A46 Newark Bypass

7.35 Applicant's Comments on Nottinghamshire County Council's Local Impact Report

Applicant's Comments on Nottinghamshire County Council's Local Impact Report

Regulation Number:	Regulation 5(2)(q)
Planning Inspectorate Scheme Reference	TR010065
Application Document Reference	7.35
Author:	A46 Newark Bypass Project Team, National Highways

Figure 2.5: Kelham Bridge location

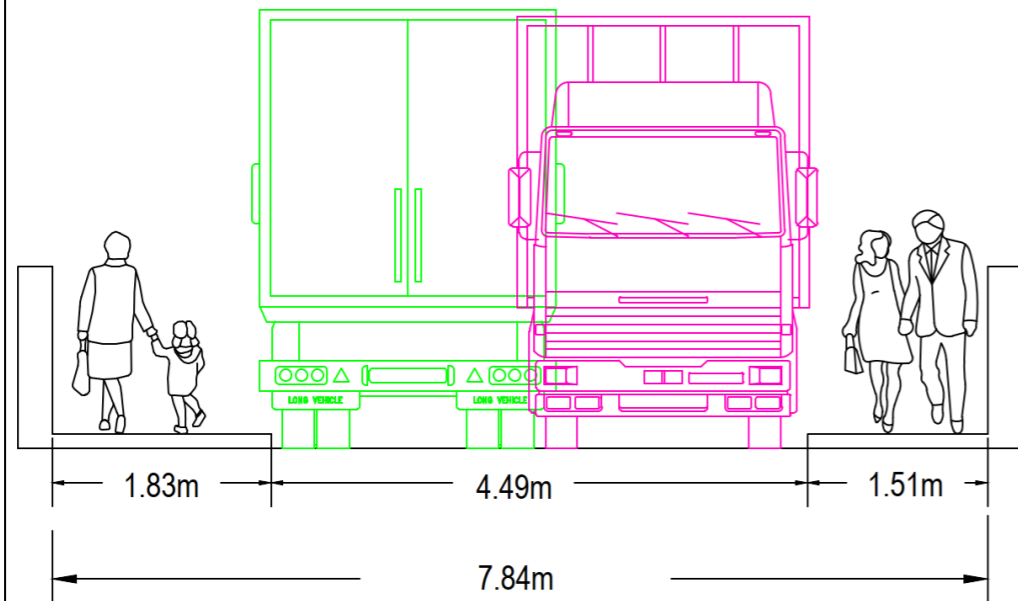
2.36.	<p>NCC would like to understand the potential impact or implications of the proposed Scheme on the operation of Kelham Bridge and how the Scheme may affect the assessment of the options and the deliverability of an improvement at the bridge. This will be discussed in more detail within Section <i>Forecast Changes in Traffic Flow</i>.</p>	<p>The Applicant notes from the information provided by NCC there would be an interface between the Scheme and option K-NI_001 in figure 2.8 of the NCC LIR. The roundabout shown on Main Steet would be partially located within an area designated as flood compensation for the Scheme as indicated by Works No. 125 on the Works Plans [AS-005].</p> <p>Traffic flows on the A617 are forecast to increase as a result of the Scheme. The increase in traffic is primarily caused by the improvements at Cattle Market Junction, where the introduction of a flyover for mainline A46 traffic frees up capacity for other movements at the roundabout. To a lesser extent, similar improvements brought about by removing A46 through traffic from the A1/A46/A17 roundabouts also contributes to the forecast increases in traffic on the A617.</p> <p>The Applicant notes that the forecast increase in traffic flow on the A617 Kelham Road quoted in Table 2.11 of the NCC LIR is incorrect. As per Tables 6-2 and 6-3 of the Transport Assessment Report [APP-193] the forecast increase on this link is 1,300 vehicles per day in 2028, rising to 1,700 vehicles per day in 2043.</p>

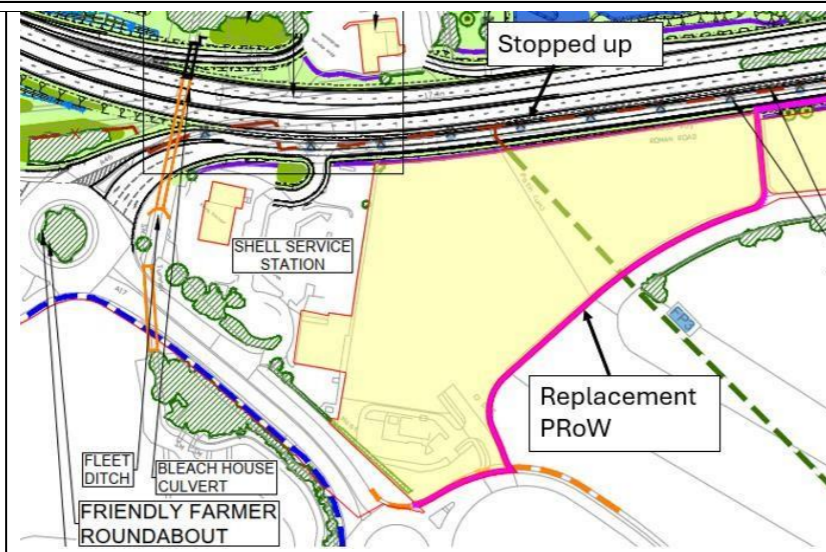
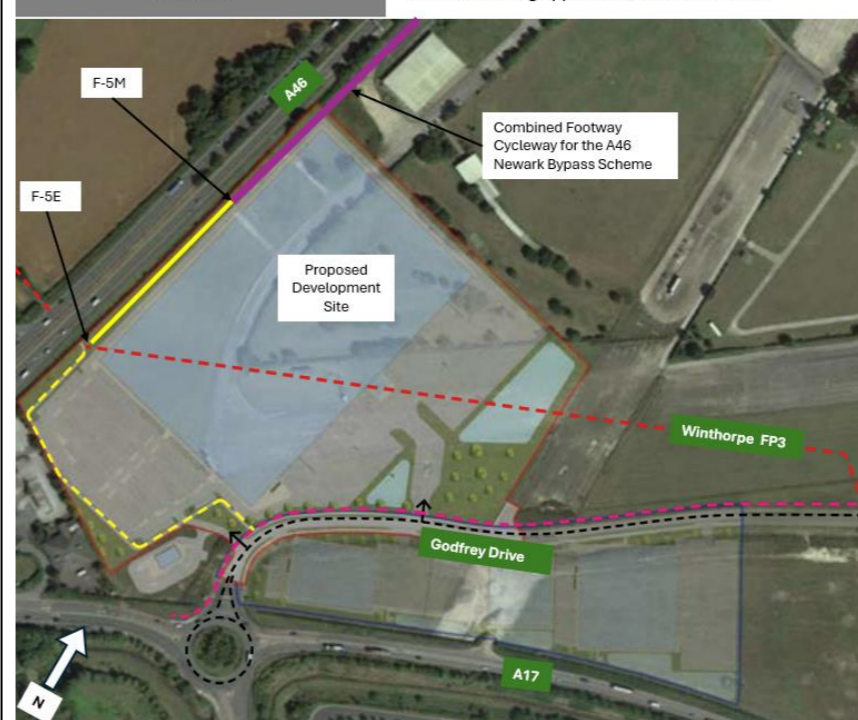
5	<p>A site located to the east of the Friendly Farmer roundabout (located to the south of the A46) has been identified within Newark & Sherwood Local Plan Site Allocation document as a strategic mixed-use development site (NUA/MU/1 (hotel/conference facility, restaurant facility to support the wider showground uses, and employment uses)). The existing PRoW running adjacent to the A46 connecting to the Friendly Farmer roundabout is proposed to be stopped up, being replaced with a new footway / cycleway passing to the southeast of the Shell service station (see extract below).</p>	<p>The Applicant confirms the route of the proposed walking and cycle route was developed in conjunction with Lindum Developments Limited (the developer of the NUA/MU/1 site) and NCC's PROW officer. The route followed the proposed footway / cycle track of Lindum Developments Limited's proposed development at that time and did not impact on any development plans for the site.</p> <p>The Applicant confirms the alignment for the combined footway/cycle track between points F-5M and F-5O on sheet 5 of the Streets, Rights of Way and Access Plans [AS-006] was chosen following consultation with multiple stakeholders, including Lindum Developments Limited, within the NSDC Local Plan allocation NUA/MU/1. The route was selected to provide a replacement to the current footpath that runs along the southbound A46. The route provides a link to the existing footpath on the A17 and intercepts Winthorpe footpath 3. The intention was that the combined footway/cycle track would run through and provide access to the proposed development. Lindum Developments Limited's plans have since been further developed with an outline planning application (reference 23/02281/OUTM) submitted to NSDC in December 2023. It is expected that this outline planning application is to be determined in December 2024. The Applicant is currently drafting a legal agreement with Lindum Developments Limited for the site to ensure that, should their application be granted, provision is made as far as possible for i) the combined footway/cycle track between the A46 and Godfrey Drive that does not conflict with the Lindum's proposed development and ii) a temporary diversion route for the footpath along the southbound A46. Should the outline planning application be granted permission and Reserved Matters be</p>

Reference	Text from Local Impact Report	Applicant's Response
	 <p>This new route would pass through the site allocation NUA/MU/1. NCC seek clarification that the proposed route would not compromise the ability of NCC / NSDC to deliver the development aspiration at this site.</p>	<p>approved, the alignment for the combined footway/cycle track would be similar to that proposed in Section 6 of the developer's Design and Access Statement but with a corridor provide along the northern boundary of the development site to provide a continuous link between F-5E and F-5M (please refer to the figure below).</p>  <p>Annotated extract from Section 6 of the Design and Access Statement, dated 27th December 2023, submitted with Outline Planning Application 23/02281/OUTM</p>
6	<p>For the proposed deceleration lane off the A46 diverge slip road, NCC seek clarification as to whether this has been designed in accordance with National Highways DMRB guidance to ensure that there is not a risk of shunt style collisions. NCC seek clarification as to whether this access would be gated given it is a private access to the Newark Showground.</p> <p>For cyclists travelling southbound on Drove Lane, using the proposed footway / cycleway, NCC seek clarification as to how cyclists will merge safely onto the road at the proposed termination point. Is there any desire line for why this route has been extended so far south off the roundabout?</p> <p>NCC seek clarification as to whether the cyclists' crossing facilities at Winthorpe Roundabout would be signal controlled.</p> <p>Road Markings for eastbound traffic in the right-hand lane and the chevron markings on the circulatory appear to conflict and push road users to exit in Lane 2.</p>	<p>The Applicant confirms the slip road has been designed in accordance with DMRB. The access will not be gated as it replaces the existing entrance off Drove Lane where the right turn off Drove Lane has been banned to improve safety and prevent vehicles queuing back onto Winthorpe Roundabout.</p> <p>Details of how southbound cyclists will merge onto Drove Lane safely will be developed during detailed design and agreed with NCC. The purpose of this route is to provide a safe walking and cycling route to the first Showground entrance.</p> <p>The crossings of the A46 will be signalised and those on Drove Lane and the A1133 will not be signalised.</p> <p>The Applicant is not clear on the point raised regarding eastbound traffic. The Applicant has reviewed all chevrons around Winthorpe Roundabout and believe these are correct for the intended vehicle movements. The Applicant will discuss this layout with NCC during detailed design.</p>

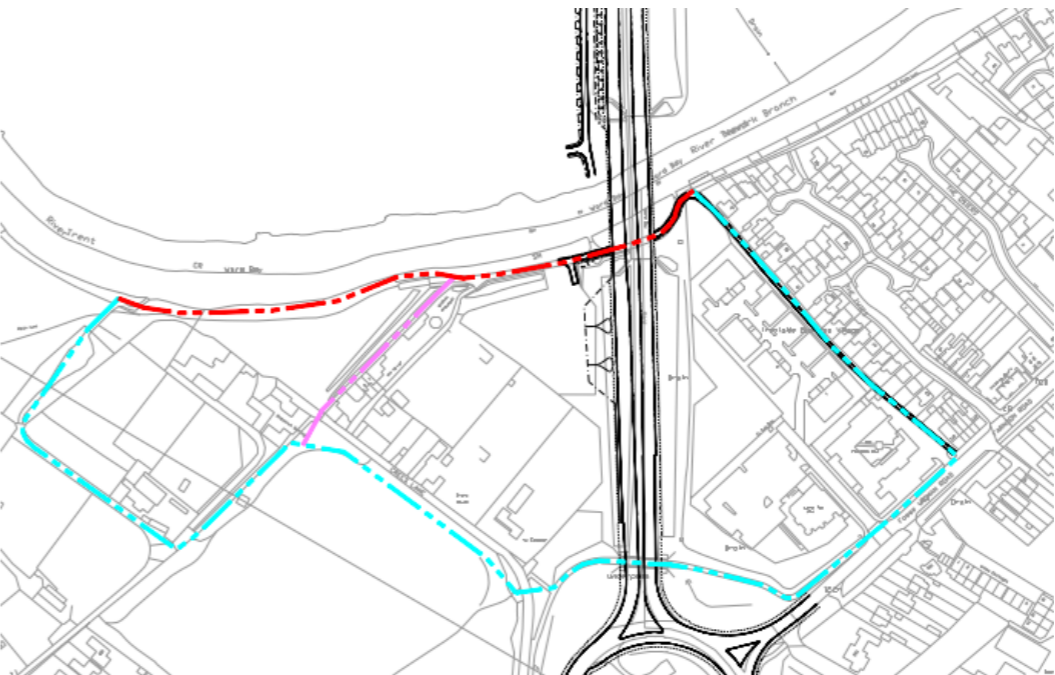
85	NCC seek clarification as to whether the temporary works areas extends into the verge of the A1; can the Applicant confirm if this is an error in drafting?	The Applicant can confirm that this is not an error in drafting and that the temporary works area reflects the requirements of the Scheme.
96	NCC seek clarification as to whether the watercourse profile and section needs realigning to suit the culvert extension?	The Works Plans adequately represent the intent of the works to be undertaken for Work No. 96. The comments raised refer to specific details that will be included within the detailed design.
104	Does the works also include the removal of the existing gantry or is this to be retained?	The gantry is removed as part of the works associated with Work No. 104

Reference	Text from Local Impact Report	Applicant's Response
106	Obscured under label for Friendly Farmer Link Road	 <p>The Applicant will correct the Works Plans [AS-005] for Deadline 3.</p>
107	NCC seek clarification as to how this attenuation pond will be accessed for maintenance and any emergency spillage issues arising.	National Highways maintenance team will have access along the new 3.0m wide footway / cycleway route for light commercial vehicles which will be able to access and close off the penstock if a spillage occurs. They can also park in an emergency for a spillage on lane 1 of the approach to Winthorpe roundabout and access from this side if needed.
124	NCC seek clarification as to the types of road closures to facilitate the construction of the proposed culvert.	The methodology for the culvert crossing under the A617 is described in section 2.6.42 of Chapter 2 of the Environmental Statement [APP-046]. Temporary traffic signals would be utilised to construct the culvert crossing in two phases.
